ECE/TRANS/WP.29/GRPE/2008/6  
20 March 2008

REGULATION No. 83

(Emissions of M<sub>1</sub> and N<sub>1</sub> categories of vehicles)

Proposal for draft amendments to Regulation No. 83

Fig. 1: Development of engine cool down times.

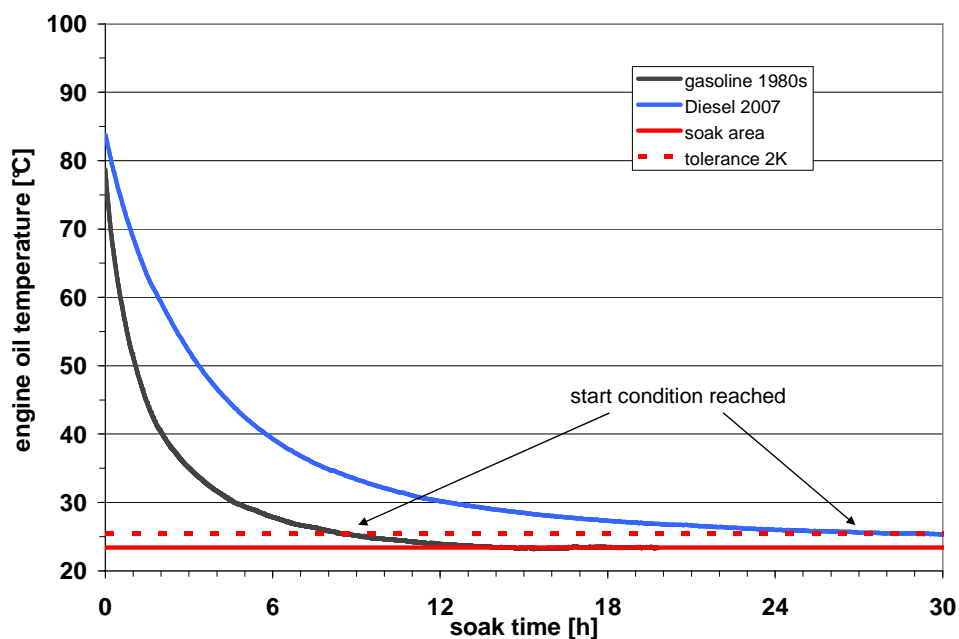
Actual vehicle/engine concepts use encapsulation measures to reduce external noise and aerodynamic drag. As a side effect this leads to extended cool down times of the power train after engine shutoff. Figure 1 shows the impact of these developments to the engine cool down times.

Contrary to the development of noise reduction and aerodynamic measures leading to longer cool down times, the preconditioning requirement of test Type I remained unchanged. The regulation defines a minimum soak period of 6 hours and a start condition of engine oil and

coolant temperature in between +/- 2°C of the temperature of the soak area (20-30 °C), before the emission test can be started. Modern vehicle concepts remain in a warmed up condition with engine temperatures above 2 K above ambient temperature for more than 24 hours. This situation causes increased workload in the development and type approval process as additional cooling fans have to be used to reduce the soak times between preconditioning cycle and emission test (forced cooling down).

The proposed amendment harmonizes the test procedures of Type I test, Type VI test, US FTP and Japan TRIAS. This means, that for the Type I test, as an alternative to the present preconditioning, a soak time of 12 to 36 hours should be introduced without any restriction of oil or coolant temperature.
